KWM-380 TRANSCEIVER (622-5093-101)  
HF-380 TRANSCEIVER (622-3580-101)  
RECEIVER-EXCITER CIRCUIT CARD A3 (638-6908-001)

SERVICE BULLETIN NO 1

PRODUCT IMPROVEMENT

P/O Control Card A8  
Figure 1

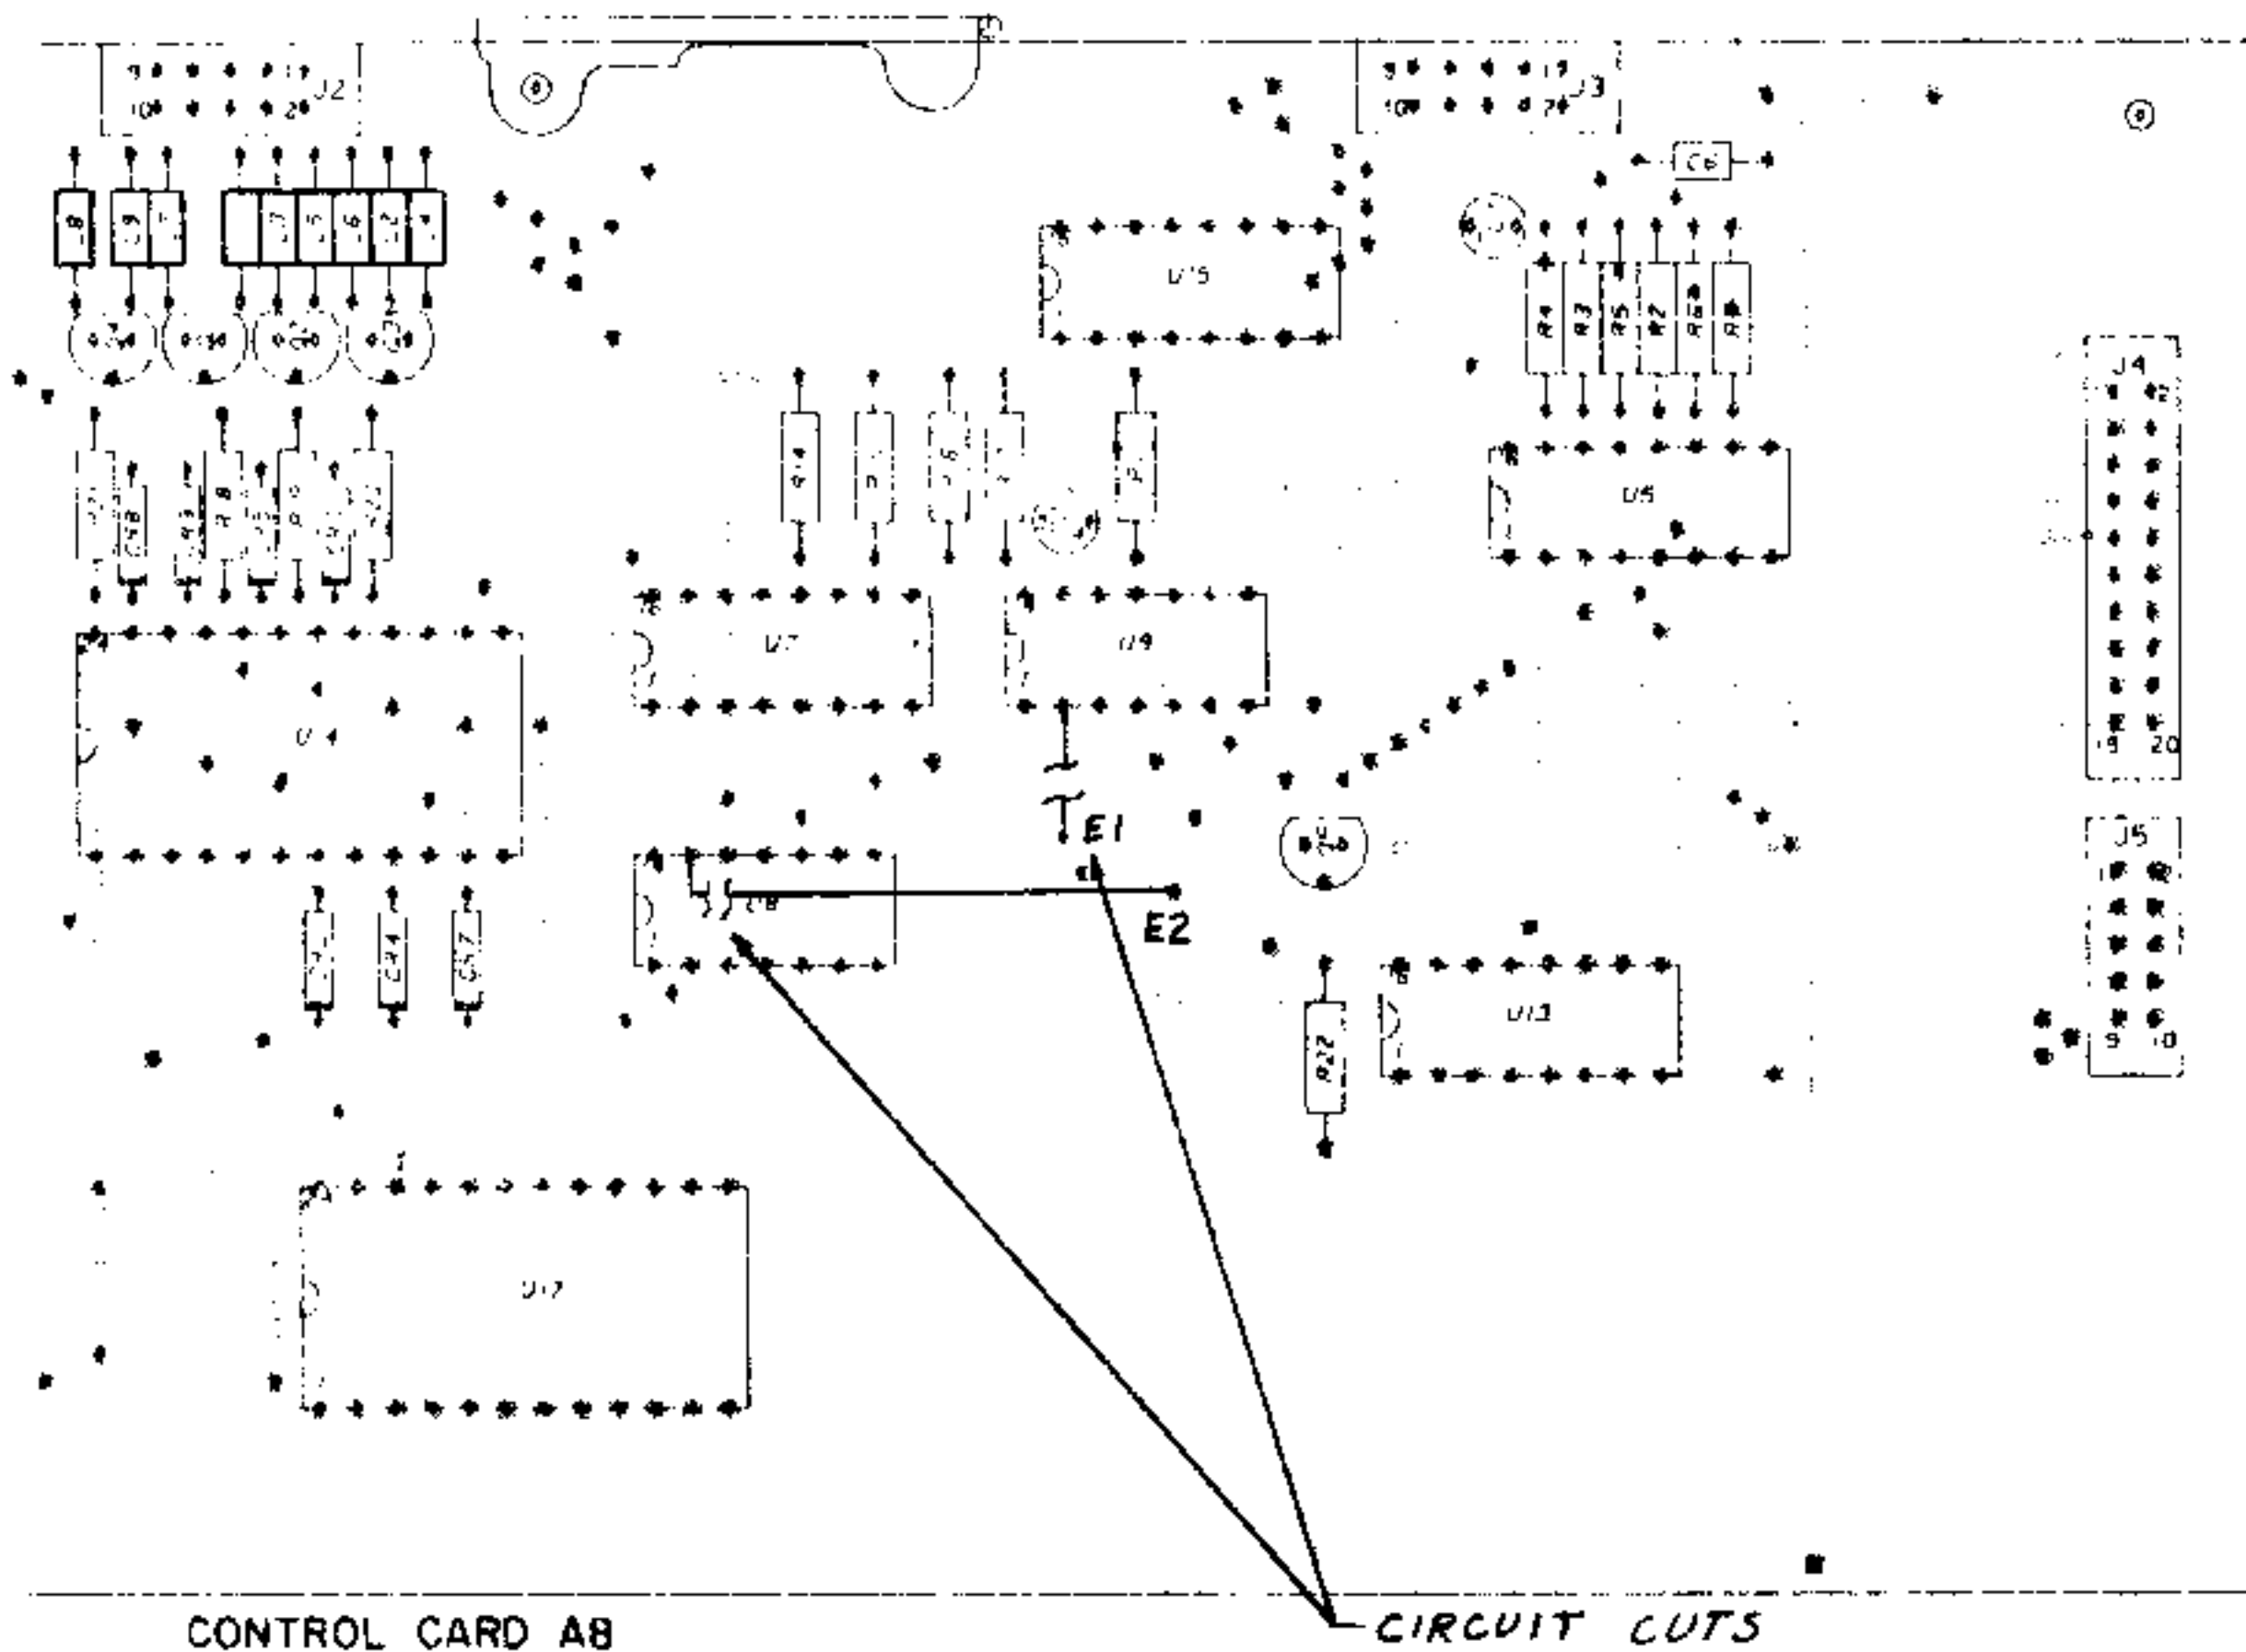
**NOTE:** Refer to the control card A8 instructions, CPN 523-0770685, figure 5, located in the back of the KWM-380/HF-380 service manuals and to figure 1 of this bulletin while performing steps E through I. Refer to figure 2 while performing steps J and K. Figure 3 shows the changes in steps F through I schematically.

- E. Remove 100- $\mu$ H coils L1 through L9 and replace them with 560- $\mu$ H coils (240-2723-050).
- F. Cut the circuit trace from U9-2 to E1.
- G. Cut the circuit trace from U8-13 to E2.
- H. On the bottom of the card, install a jumper wire (422-2400-020) from E1 to U9-4.
- I. On the bottom of the card, install a jumper wire (422-2400-020) from E2 to U8-12.
- J. Install two cable clamps (150-0873-010) in the synthesizer compartment as shown in figure 2.
- K. Route the two cables on the back of the synthesizer assembly through the cable clamps and out the end of the card cage. This will hold the cables away from the circuit card components.
- L. Reassemble the transceiver in the reverse order of disassembly.

P/O Receiver/Exciter A3, Component Installation Diagram  
Figure 1 (Sheet 1 of 2)

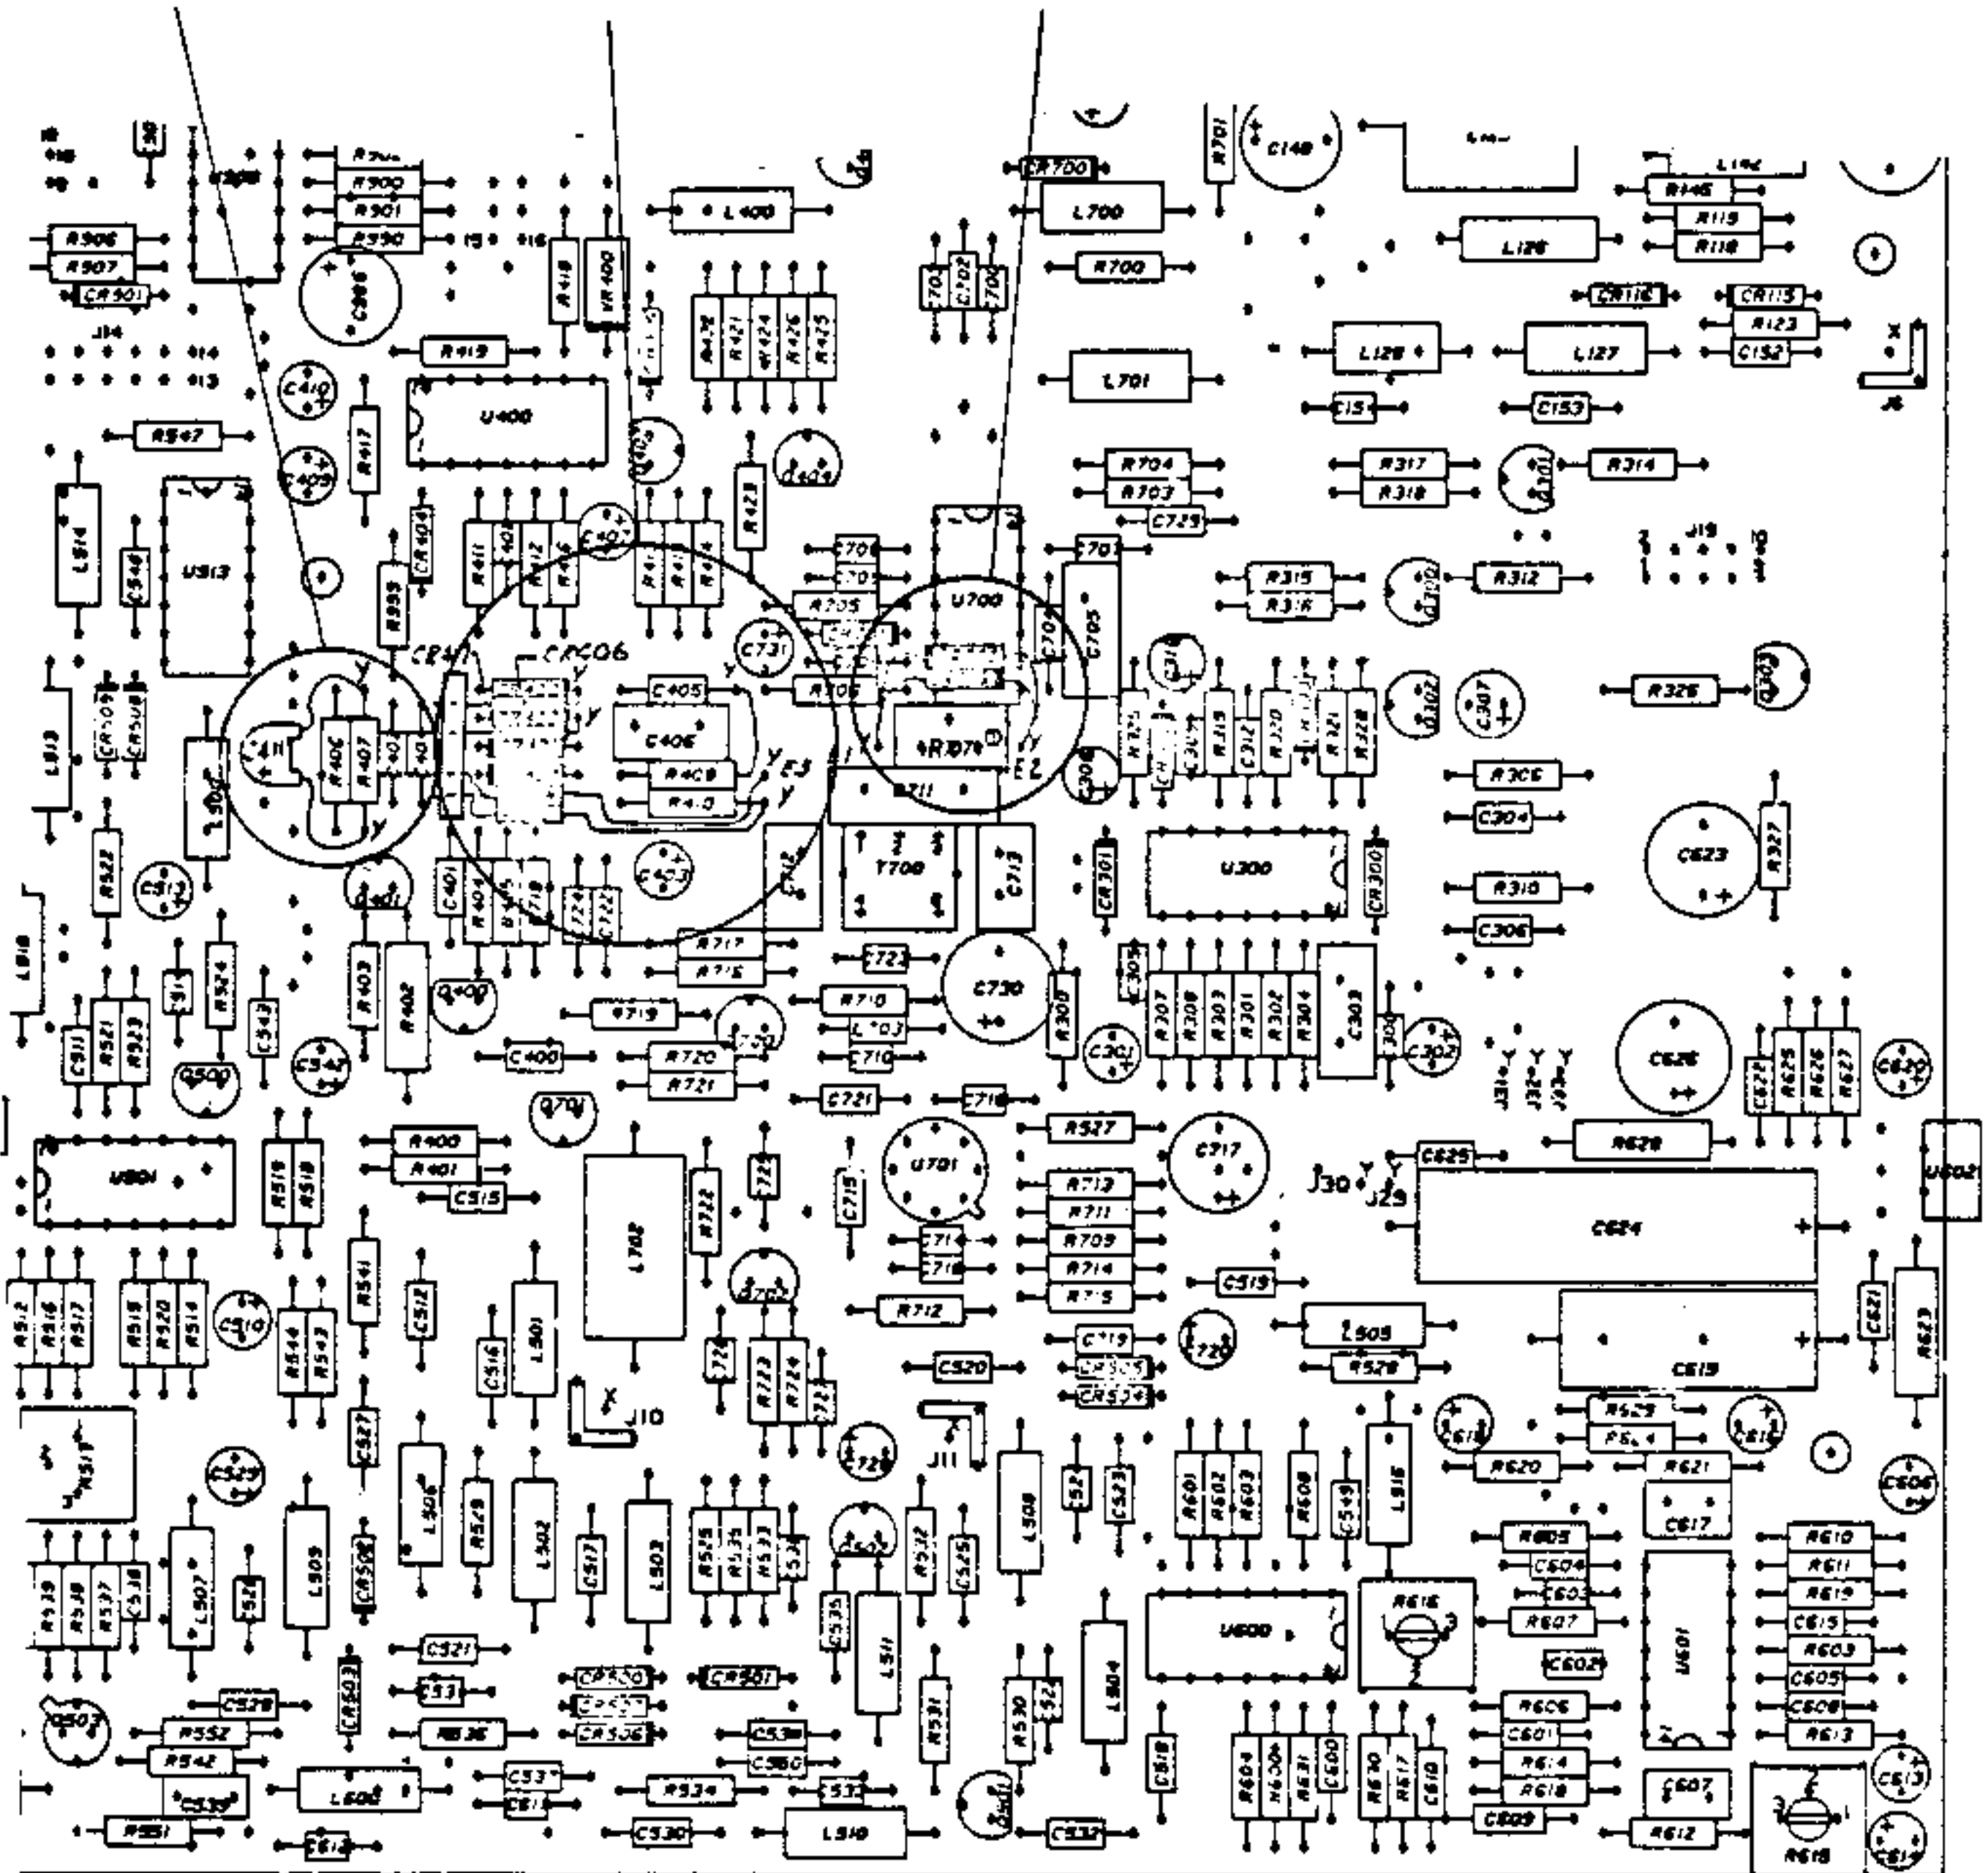
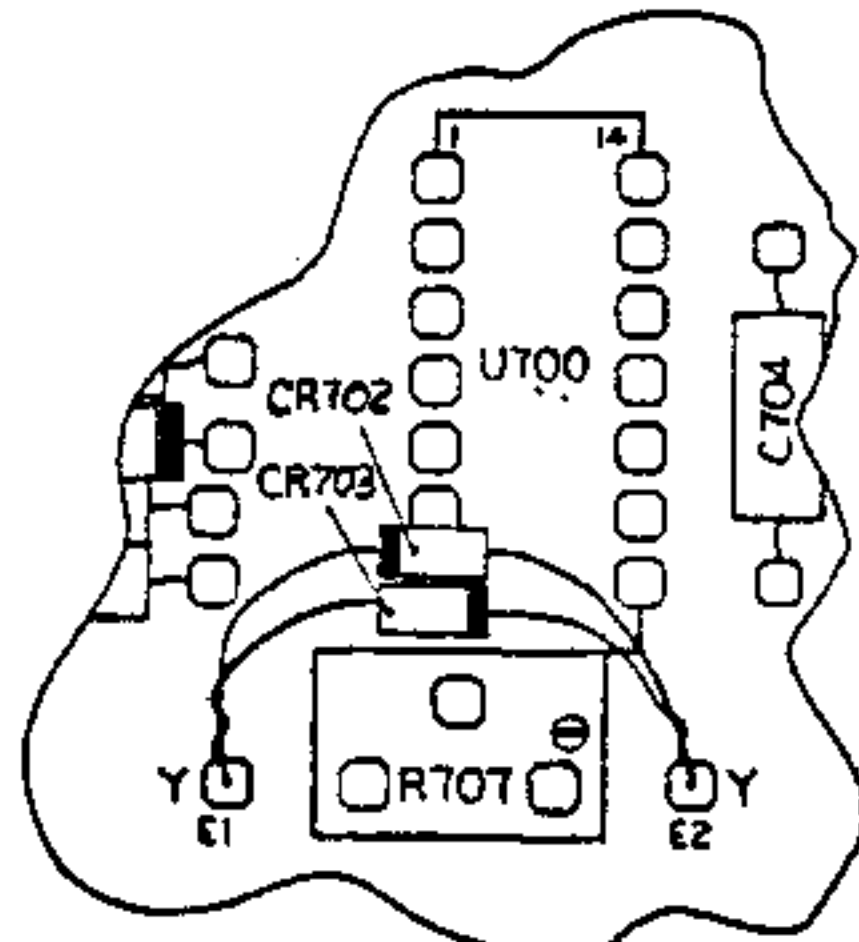
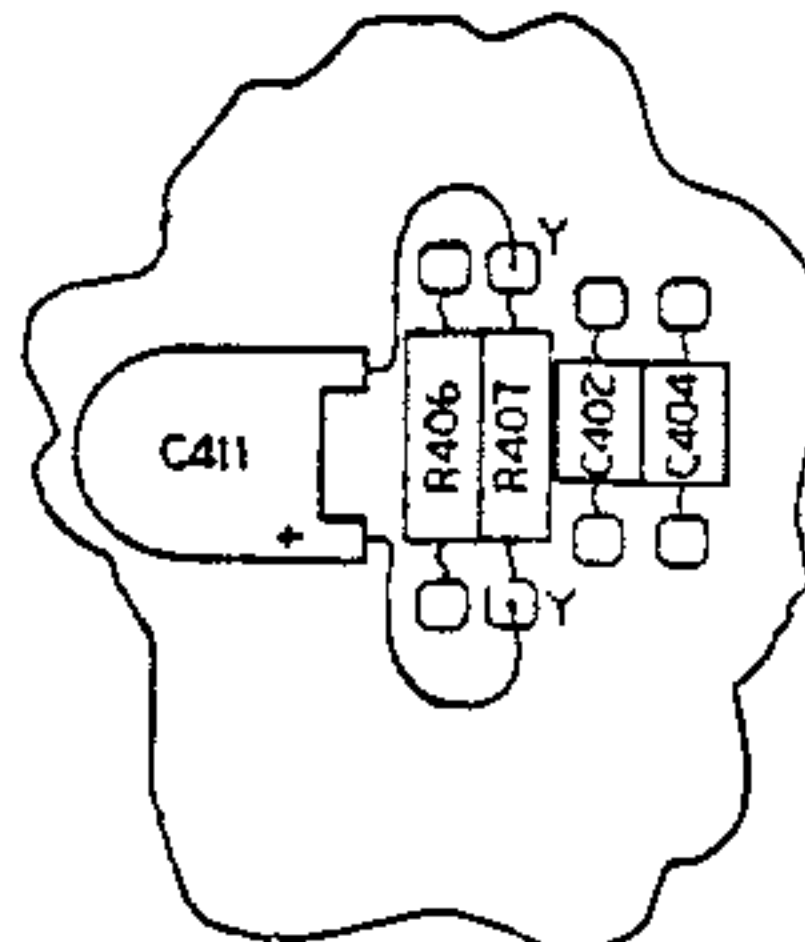
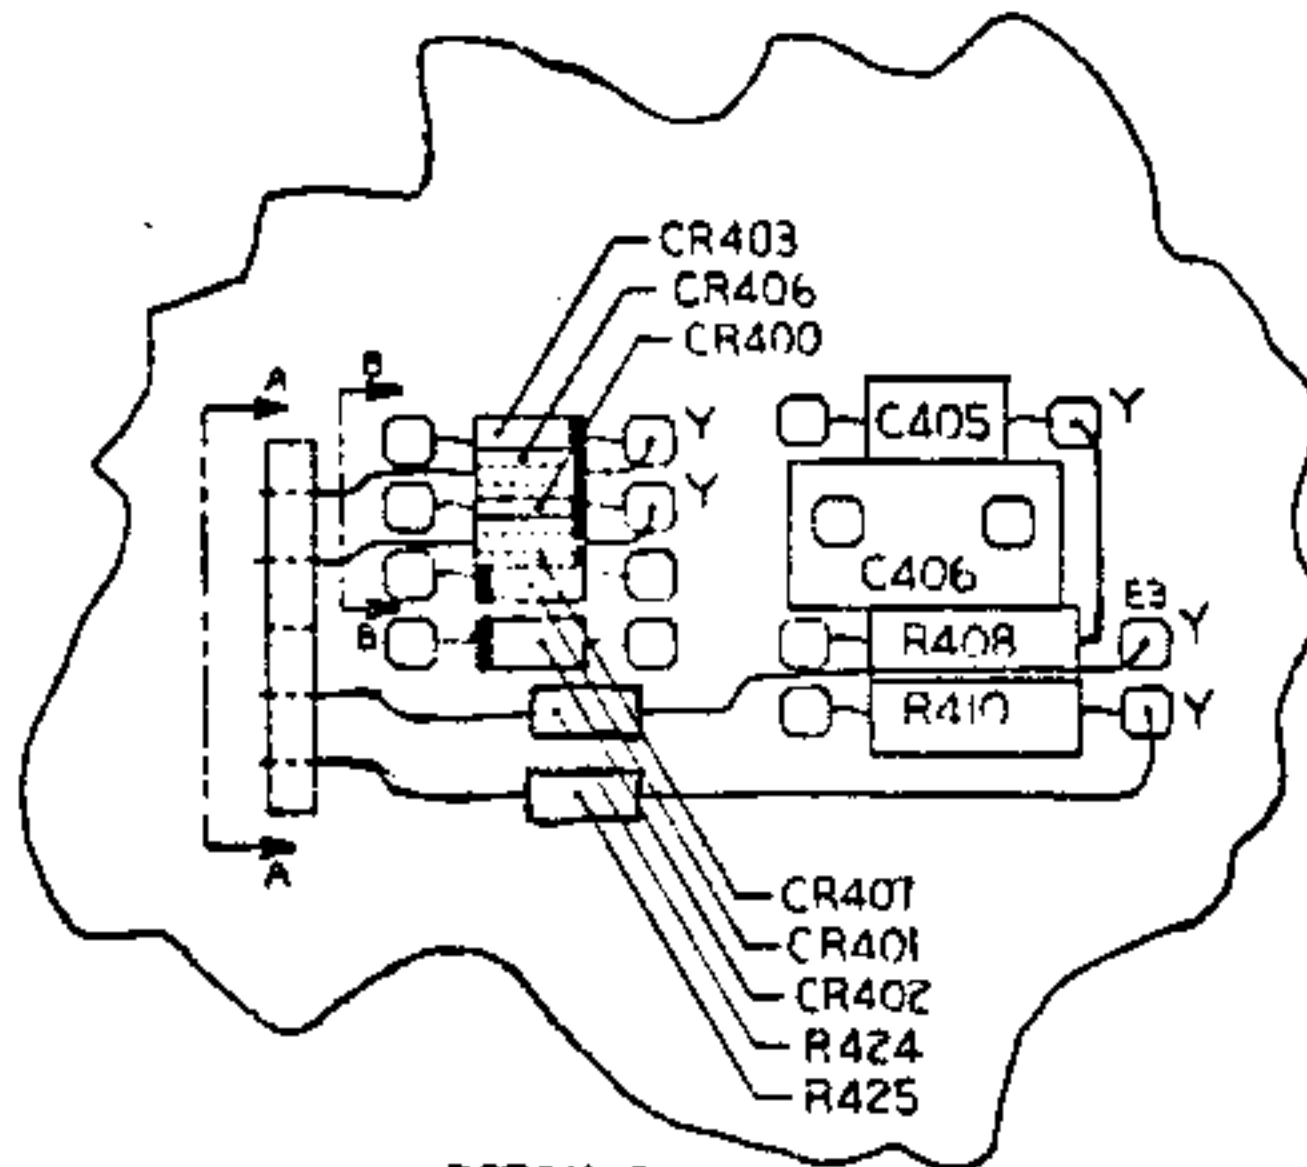
- C. Install contacts, 372-2656-130 (square pins) at E1 and E2 (holes in board) and solder. Refer to figure 1, detail A.
- D. Install 1N4454 diode CR702 (353-3644-010) with cathode to E1 as shown in figure 1, detail A.
- E. Install 1N4454 diode CR703 (353-3644-010) with cathode to E2 as shown in figure 1, detail A.

- F. Remove both leads of resistor R407 and install a contact (372-2656-130) in each hole.
- G. Connect the R407 leads to the new contacts.
- H. Install 100- $\mu$ F capacitor C411 (184-9102-100) to the new contacts with the positive side to the bottom of R407 as shown in figure 1, detail C.

- K. Position 1N4454 diode CR406 (353-3644-010) as shown in figure 1, detail B, section BB. Connect the cathode end to the contact installed in step I.

- L. Position 1N4454 diode CR407 (353-3644-010) as shown in figure 1, detail B, section BB. Connect the cathode end to the contact installed in step J.

- S. Cut a terminal strip (797-3615-001) into one block of five holes.
- T. Position the terminal block as shown in figure 1, detail B, and secure it to the circuit card using commercially available epoxy or bonding adhesive.
